Staff Report

Infill Housing Design Review Committee

File Number: 11-C-21-IH

Location: 3119 Johnston St. Parcel ID 81 | G 007 02

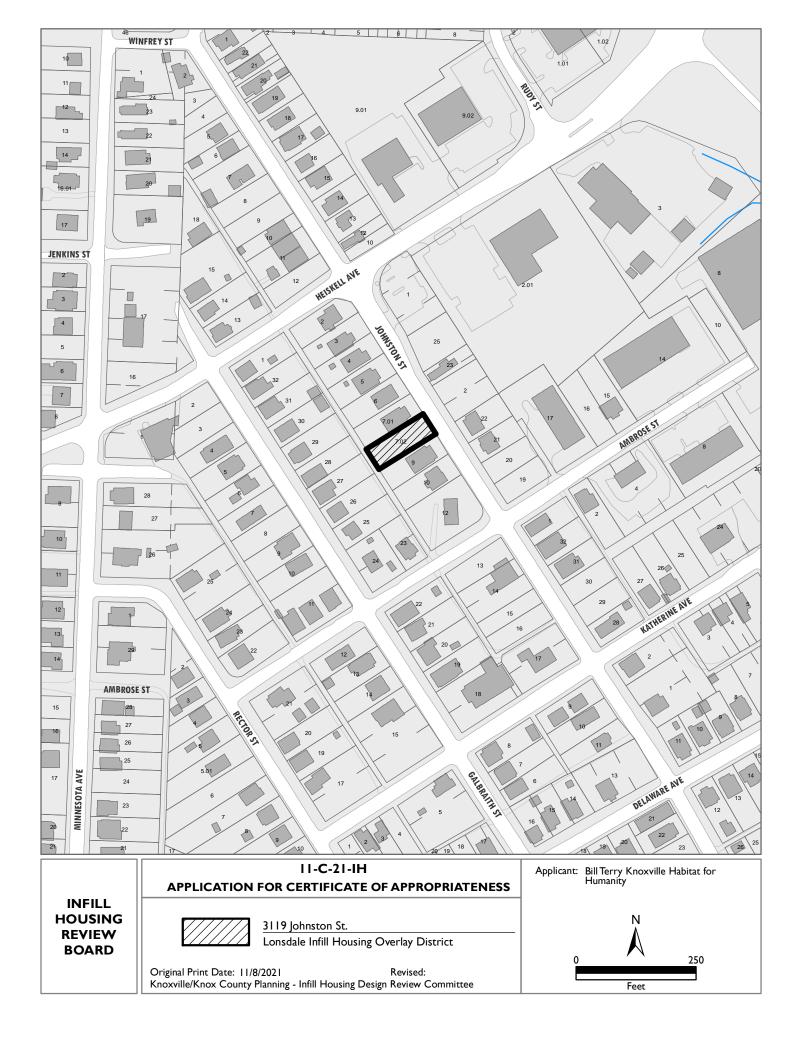
1. The house is proposed to be set 27' from the front property line, with the partial-width front porch at 21' from

the front property line. The average front setback of the block is 34.9', with the adjacent houses at 34.5' and 33'. The proposed new house should be moved slightly towards the rear of the property, to align with the adjacent houses (30'-34'). The site plan shows a walkway from the front porch to the street.

- 1) Modify front setback to be consistent with adjacent historic houses on the block;
- 2) Modify porch supports to be larger than proposed 5 by 5 posts;
- 3) Incorporate window trim on front and side elevations;
- 4) Select a steeper pitch for front-gable roof (6/12 or more);
- 5) Use lap siding with an overlap instead of Dutch lap or flush panel siding.
